SUBJECT: Forwards response to NRC 780125 ltr re long-term overpressure transient protection. Includes description of long-term sys to be employed at facilities.

Re: Docket No. 50-275
Docket No. 50-323
Diablo Canyon Units 1 and 2

Startup and Shutdown Overpressure Protection

OVERPRESSURE PROTECTION

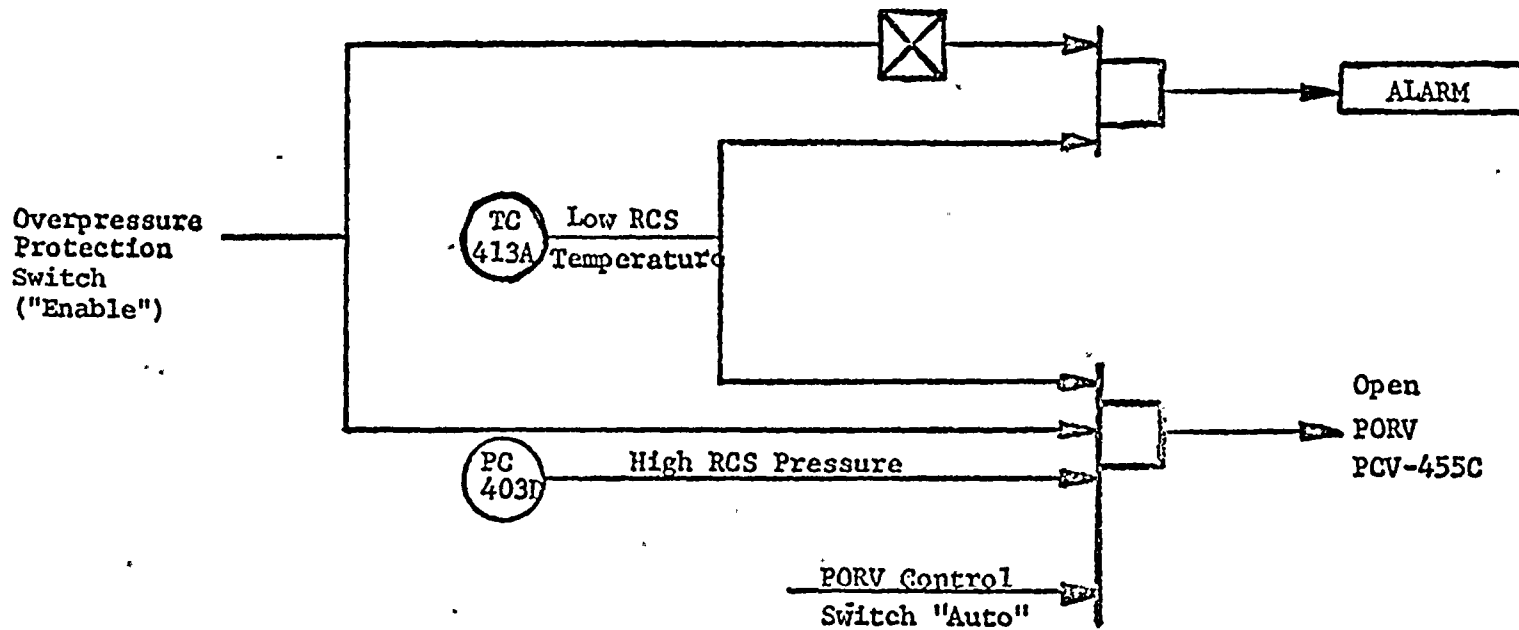
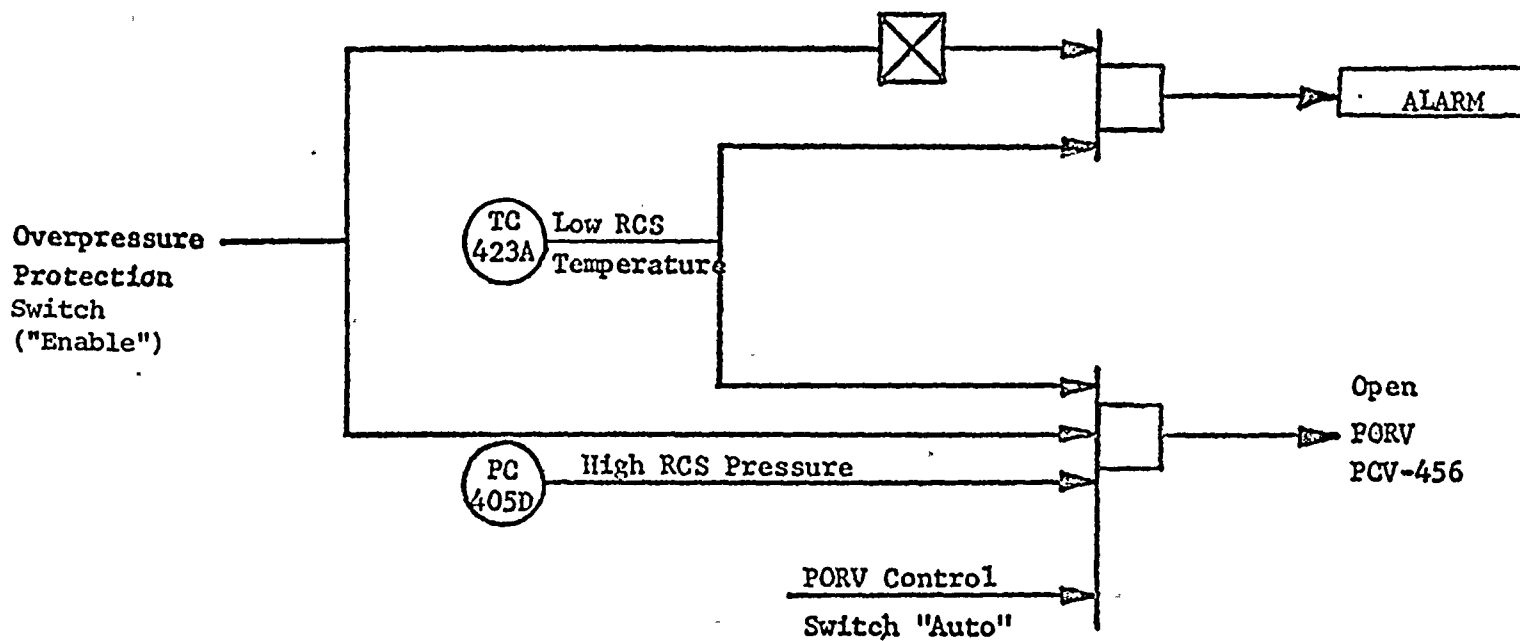
4. Provide a description of the system including relevant P&I drawings and electrical schematics.

A schematic of the System is attached. There are two independent channels, one connected to pressurizer power-operated relief valve PCV-455C, and the other to PCV-456. The channel connected to PCV-455C is described below. The channel connected to PCV-456 is similar.

The system opens PCV-455C when all four of the following conditions are met:

- a) Temperature sensed by Temperature Comparitor TC-413A is below 330°F,
- b) The enable switch located on the main control board is in the "enable" position,
- c) Pressure sensed by Pressure Comparitor PC-405D is greater than 450 psi, and
- d) The PORV Control Switch is the in the "auto" position.

To provide for alarming of the system, a main annunciator input is activated when the temperature as sensed by Temperature TC-413A is below 330°F and the enable switch on the main control board is not in the "enable" position.
